Work Order ID 160475

Item Name: Strut Tube

APICAL INDUSTRIES, INC.
dba DART AEROSPACE

ENGINEERING CHANGE NOTICE NO. 05397		SHEET 1 OF 1	
DWG NO. 647.7700	REV: A	PREPARED BY T. CROSS	DATE: 05/02/16
DWG TITLE: STRUT ASSY			
APPROVED BY: ENGR <i>[Signature]</i>	MFG <i>[Signature]</i>	QC <i>[Signature]</i>	EFF: <i>[Signature]</i>
REASON: REVISED DIMENSION			EFFECT ON DWG ☐ INC. ☒ UNINC.
			ECR: 16-028
			ACTION LIST: 1.

SHEET 1, NOTES IS:

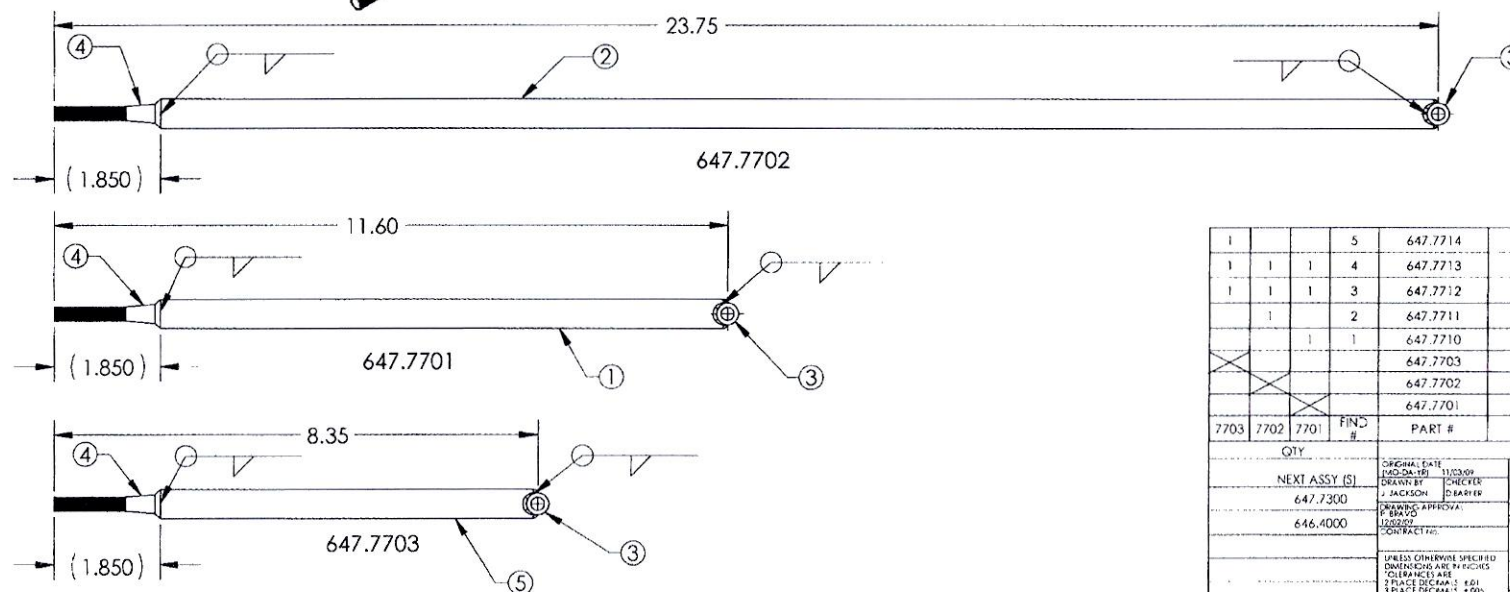
REASON: REVISED FINISH CALLOUT AS PER ECR 15-209

- 1 MATERIAL: 4130 STEEL PER AMS-T-6736, .50" OD, .083" WALL THK.
- 2 MATERIAL: 4130 STEEL PER AMS-T-6736, .375" OD, .075" WALL THK.
- 3 MATERIAL: 4130 STEEL PER AMS-T-6736, .324" OD.
- 4 FINISH: PRIME IAW MIL-P-2337J TYPE I CLASS N; 1-2 MIL MAX
5. DEBURR AND BREAK ALL SHARP EDGES
6. IDENTIFY IAW MPP-120.
- 7 WELD IAW MIL-STD-2219. TIG WELD WITH FILLER ROD
- 8 FINISH: CAD PLATE IAW QQ-P-416F CLASS I TYPE II
- 9 MASK THREAD PRIOR TO FINISH

- 1 MATERIAL: 4130 STEEL PER AMS-T-6736, .50" OD, .083" WALL THK.
- 2 MATERIAL: 4130 STEEL PER AMS-T-6736, .375" OD, .075" WALL THK.
- 3 MATERIAL: 4130 STEEL PER AMS-T-6736, .324" OD.
- 4 FINISH: PRIME IAW MIL-P-2337J TYPE I CLASS N; 1-2 MIL MAX
- 5 DEBURR AND BREAK ALL SHARP EDGES
- 6 IDENTIFY IAW MPP-120.
- 7 WELD IAW MIL-STD-2219, TIG WELD WITH FILLER ROD
- 8 FINISH: CAD PLATE IAW MIL-C-5541 CLASS 1A
- 9 MASK THREAD PRIOR TO FINISH
